UNITED STATES PATENT AND TRADEMARK OFFICE

APPLICATION NO.	FILING DATE	FIRST NAMED INVENTOR	ATTORNEY DOCKET NO.	CONFIRMATION NO.
10/516,810	06/20/2005	Grigory Valentinovich Gelikonov	76700/00009	7308
23380 7590 06/08/2007 TUCKER ELLIS & WEST LLP 1150 HUNTINGTON BUILDING 925 EUCLID AVENUE CLEVELAND, OH 44115-1414			EXAMINER COOK, JONATHON	
			ART UNIT 2886	PAPER NUMBER
			MAIL DATE 06/08/2007	DELIVERY MODE PAPER

Office Action Summary	Application No. 10/516,810	Applicant(s) GELIKONOV ET AL.	
	Examiner Jonathon D. Cook	Art Unit 2886

(modified figure 9)

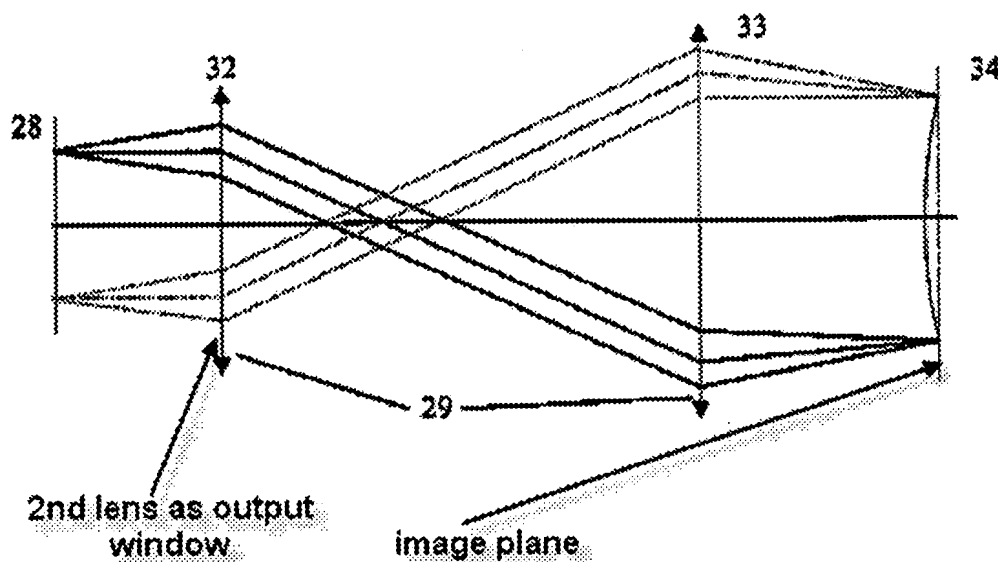
Regarding **Claims 28 & 29**, the AAPA discloses and shows in **fig. 9** (see below)

that the 2nd lens functions as the output window and is near the image plane of the end face of the distal part of the optical fiber;
